# Lessons Learned from FDC Visit to FNAL

Daniel S. Carman  
Jefferson Laboratory  
March 6, 2007

On January 25, 2007 Daniel Carman, Simon Taylor, Brian Kross, and Tim Whitlatch visited the wire chamber lab at Fermilab (FNAL) to discuss details of design of the Forward Drift Chamber (FDC) system with Karen Kephart. Karen is the group leader of the FNAL wire chamber lab. The meeting lasted from roughly 10:00 a.m. to 4:00 p.m. and included a tour of the wire winding lab. We are also in negotiations with FNAL to do the wire winding for the FDC planes and for the full-scale prototype. This document represents a report reviewing the discussions. The agenda for the meeting is included in the appendix to this document, however, not all agenda items were formally discussed.

Figure 2: Alignment target scheme recommended for all three STB and HVTB boards.

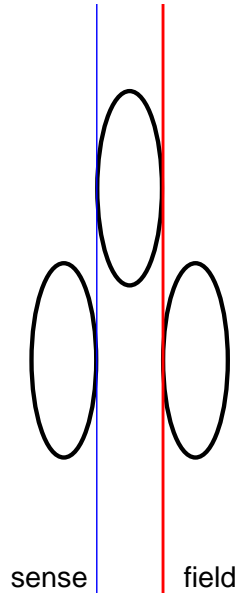
5). Karen recommended that we use wire alignment targets on the STB and HVTB boards as shown in Fig. 2. These targets need to be specified with a tight precision. They

should be located on all three of our STB and HVTB boards for easy reference. They allow for a rapid visual check on wire alignment and rotations of the wire frame relative to the wires.
